May 16, 2013

Subject: Energy Star[®] Lamps V1.0 Specification Draft 4.0

Case 1: A bright spot at top, which could be anywhere in the 0° to 135° region.

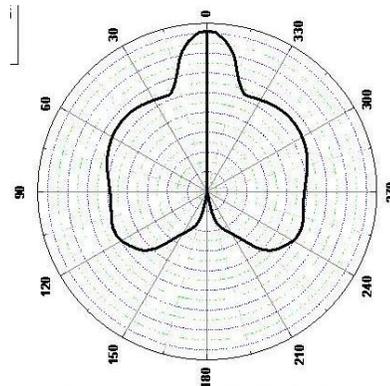
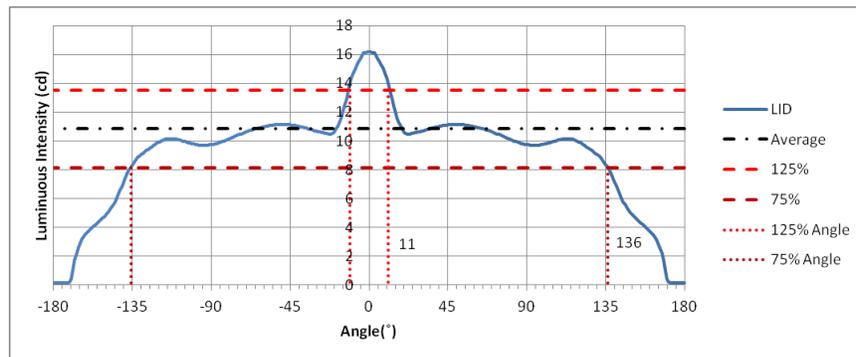
Intematix’s objection: Allowing 10% of the measured intensity values to vary beyond 25% to a specified maximum of 50% beyond the average can result in intense or dim regions such as at the 0° point along the polar axis, but could be anywhere in the distribution. The Draft 3 version prevents these concerns by ensuring that all points fall within 20% of the mean intensity in the 0° to 135° range.

Energy start draft 4 criteria			Result (Numerical SUM on 1 degree data)	PASS/FAIL
1	[0-135] uniformity <	50%	Max 149.53% @ 0° Min 77.19% @ 135°	PASS
2	[0-135] within 25%	90%	8.8%data @>125%zone 0.2%data @<75%zone	PASS
3	Flux % [135-180]>	5%	7.57%	PASS
			FINAL RESULT	PASS

Removal of the 90% clause.

"Each luminous intensity measured value (candelas) shall vary by no more than 25% from the average of all measured values". This prevents data points from going beyond 25% of the average.

Case 2: A dark spot at top, which could be anywhere in the 0° to 135° region.

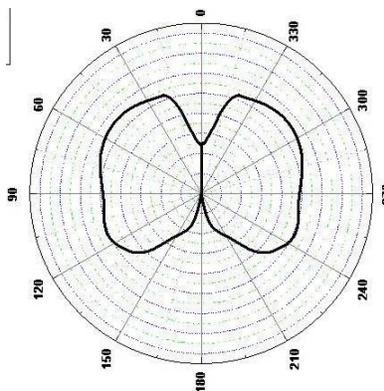
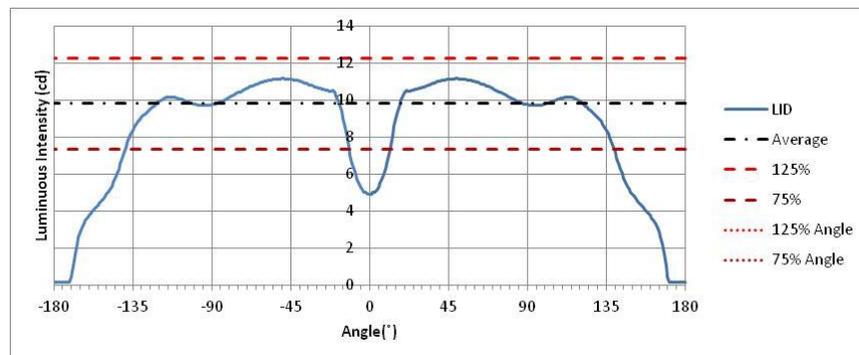
Energy start draft 4 criteria			Result (Numerical SUM on 1 degree data)	PASS/FAIL
1	[0-135] uniformity <	50%	Max 113.72% @ 49° Min 50.01% @ 0°	PASS
2	[0-135] within 25%	90%	0.0%data @>125%zone 8.8%data @<75%zone	PASS
3	Flux % [135-180]>	5%	7.69%	PASS
			FINAL RESULT	PASS

Case 3: Combination of bright spot and dark spot, which could be anywhere in 0° to 135° region.

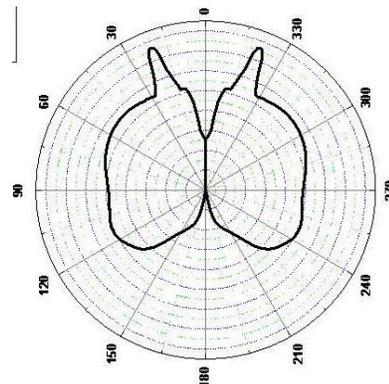
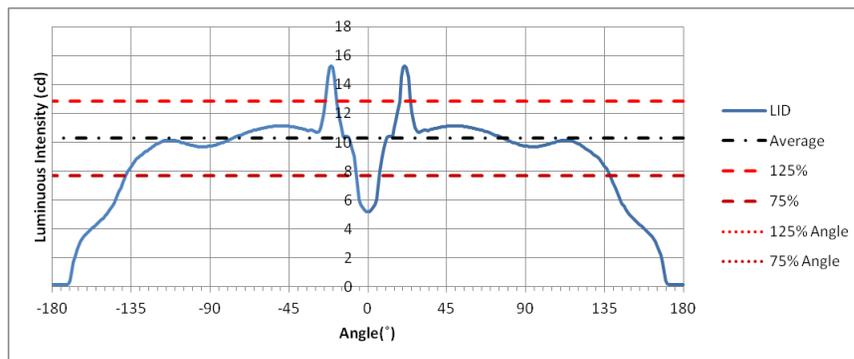
Energy start draft 4 criteria			Result (Numerical SUM on 1 degree data)	PASS/FAIL
1	[0-135] uniformity <	50%	Max 148.95% @ 21° Min 50.62% @ 0°	PASS
2	[0-135] within 25%	90%	4.4%data @>125%zone 5.1%data @<75%zone	PASS
3	Flux % [135-180]>	5%	7.56%	PASS
			FINAL RESULT	PASS
